**CITY OF ST. HELENS PLANNING DEPARTMENT
STAFF REPORT**

Appeal AP.2.22 (of Subdivision Preliminary Plat, SUB.2.22)

ZONING: Moderate Residential, R7
LOCATION: 4N1W-6D-604 and 4N1W-6AD-2600
PROPOSAL: 46 lot Planned Development Subdivision Preliminary Plat

FIGURE 1-3: EXISTING SYSTEM EVALUATION - D/D AND POTENTIAL OVERFLOW LOCATIONS

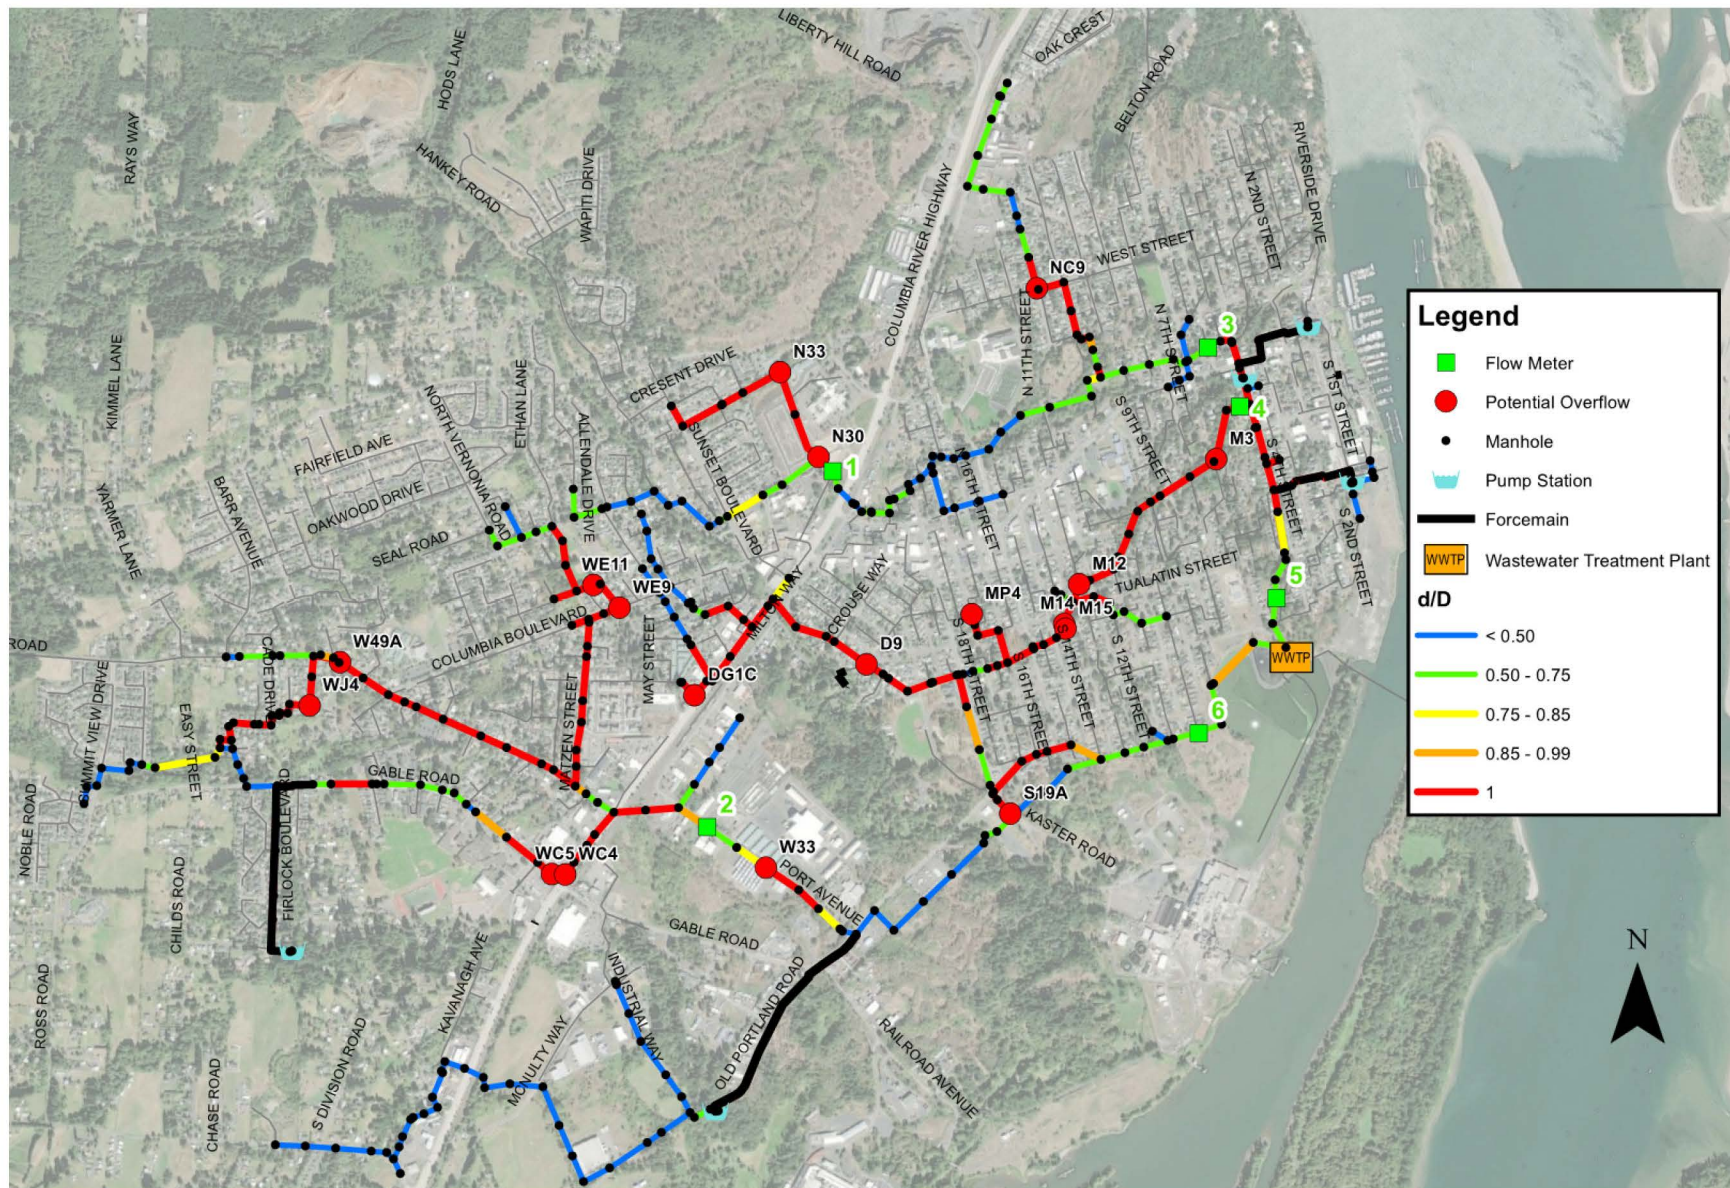
Per Section 1.3.4 PIPELINE CAPACITY of the Wastewater Master Plan (WWMP), the City's wastewater collection system capacity was evaluated at its current condition and for the anticipated 20-year future conditions. Using the 5-year, 24-hour design storm event, the existing wastewater collection system was shown to be operating at or above capacity with several manholes having the potential to overflow. It was noted that the deficiencies found in the system was caused by high peak flows and undersized trunklines. (See Attachment A). The sewer trunklines which would potentially serve the Comstock Planned Development is one of the trunklines that is presently operating at or above capacity with at least three manholes with the potential to overflow per the WWMP. (See Figure 1-3 of Attachment A)

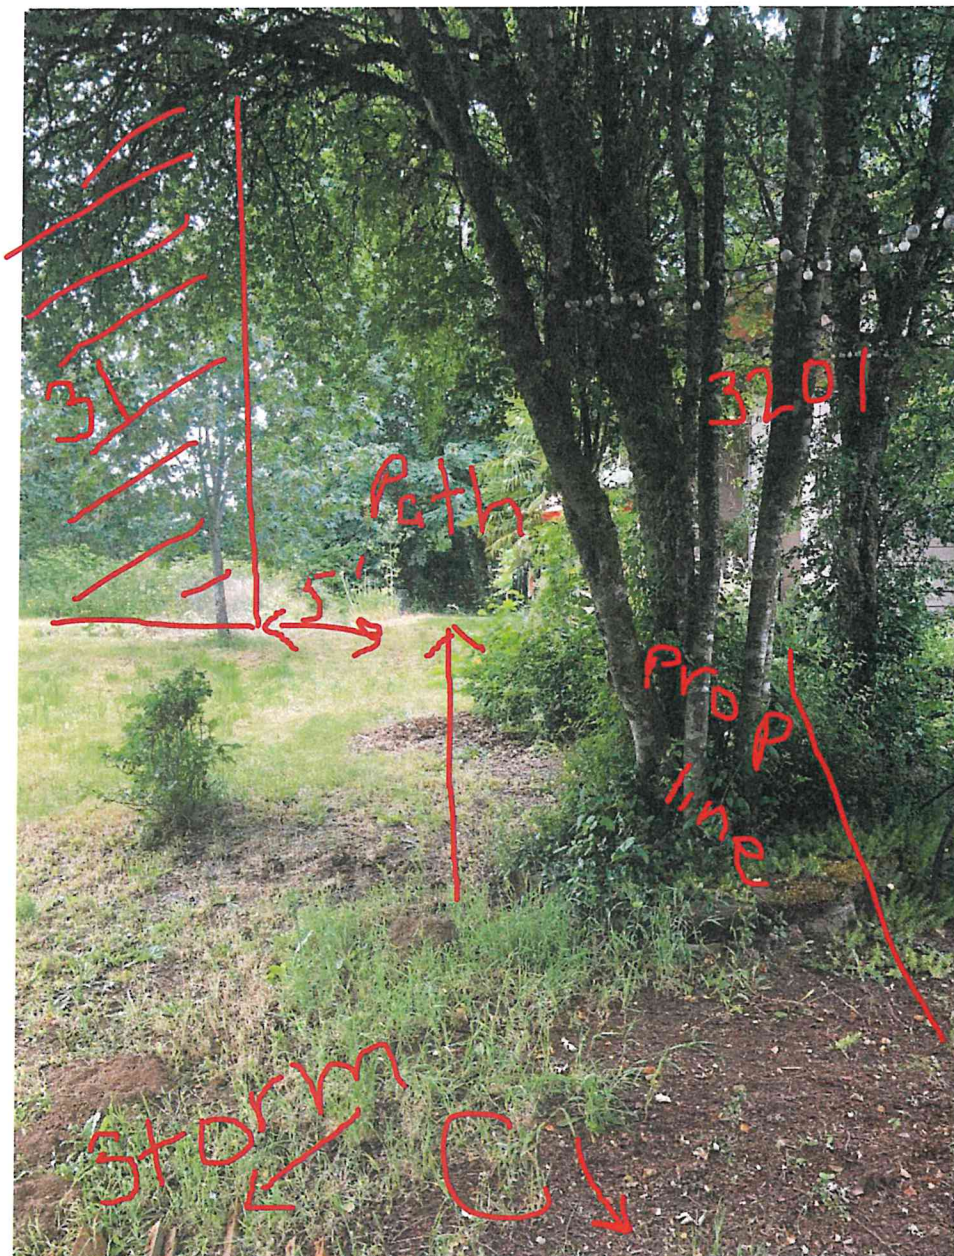
As of the date of this staff report, the following agency referrals/comments have been received that are pertinent to the analysis of this proposal:

City Engineering Manager: See **attached** Engineering Staff Report dated June 22, 2022

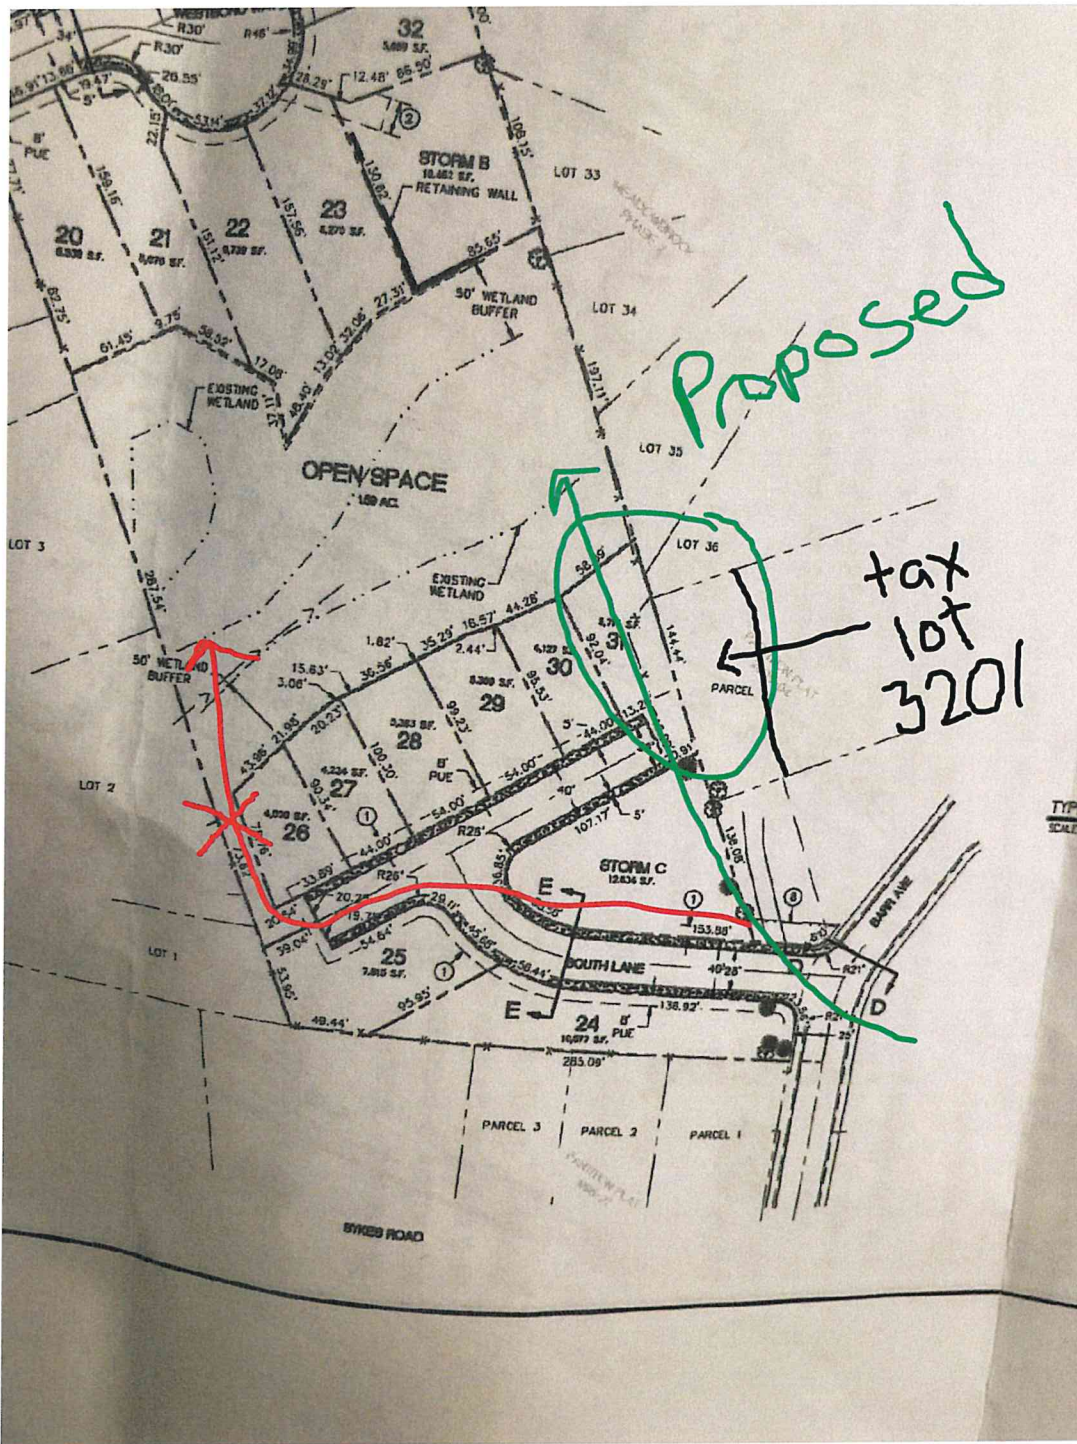
Bonneville Power Administration: Bonneville Power Administration (BPA) has reviewed the above-referenced materials and its relationship to the BPA transmission line easement that this project impacts. BPA does not have any objection to this project as long as, except as shown on the drawings supplied with the Notice of Public Hearing, all buildings and facilities remain off of the BPA right-of-way. We do request, however, that the following statement be forwarded to the property owners that are adjacent to the right-of-way to help ensure public safety and reliable operation of BPA's facilities.

Portions of the property are encumbered by easements for high-voltage transmission lines owned by the Bonneville Power Administration (BPA). BPA has acquired rights for these easements that limit the landowner's use of this area. BPA has the right of ingress and egress, and the right to keep the easement free and clear of all buildings, sheds, fences, roads, in-ground and above-ground swimming pools, trampolines, or any other type of structure, trees, and all vegetation. All activities planned within the BPA easement need to be reviewed by BPA prior to

their occurrence. Do not build, dig, install utilities, plant, or burn within the easement area. For further questions or concerns regarding any proposed uses of the easement you may contact BPA Real Estate Field Services by calling (800) 836-6619.

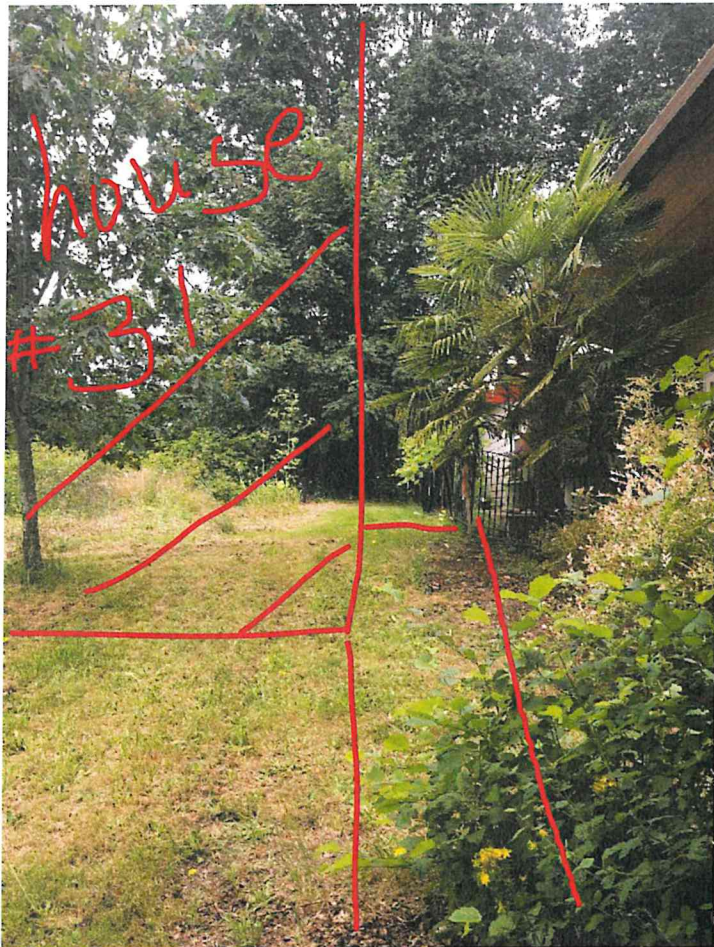
The first step to a Planned Development proposal is to adopt a Planned Development overlay zone. This overlay zone is necessary to use the flexibility of Chapter 17.148 SHMC. **Such an overlay zone is proposed via file PD.2.22.** Though a separate matter, this Subdivision Preliminary Plat approval shall be contingent on successful adoption of a Planned Development overlay since it would not be possible without it.

The Planned Development overlay zone allows flexibility to the provisions of the base zoning district. The site is zoned R7 and this zone will be the focus in considering zoning flexibility per **SHMC 17.148.080 as follows:**
